Ensure Proper Clearance Between A/C Line and Brake Line Classification Campaign Bulletin Section/Group 18 - Thermal Country/Region Asia Pacific.

Chasemouter	Campaign Dalloun	occurring of oup	Management	country/region	Europe
Year	2015	Model	Model S	Version	RHD Dual Motor

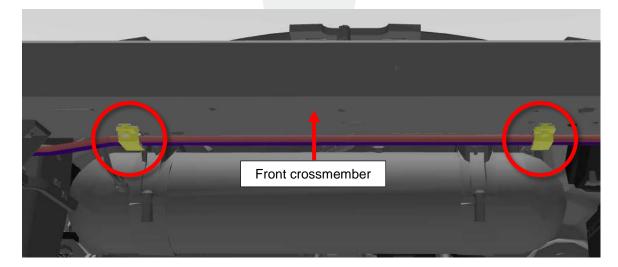
- 1. Remove the cowl screen (refer to Service Manual procedure 12250902).
- 2. Measure the distance between the A/C line and the front brake line (Figure 1):
 - If there is at least 5 mm of clearance, no additional work is needed. Discontinue this procedure and reinstall the cowl screen.
 - If there is less than 5 mm of clearance, continue this procedure.

- 7. Have an assistant monitor the clearance between the A/C line and brake line (Figure 1). Gently adjust the position of the A/C line until there is 5 mm of clearance.
- 8. Resecure the A/C line fasteners.
- 9. Inspect the brake lines near the booster. Replace the front brake line bundle if any of the following are true (refer to Service Manual procedure 33034502):
 - The rubber on the brake lines is worn
 - The brake lines touch each other
- 10. Reinstall all components that were removed for access.
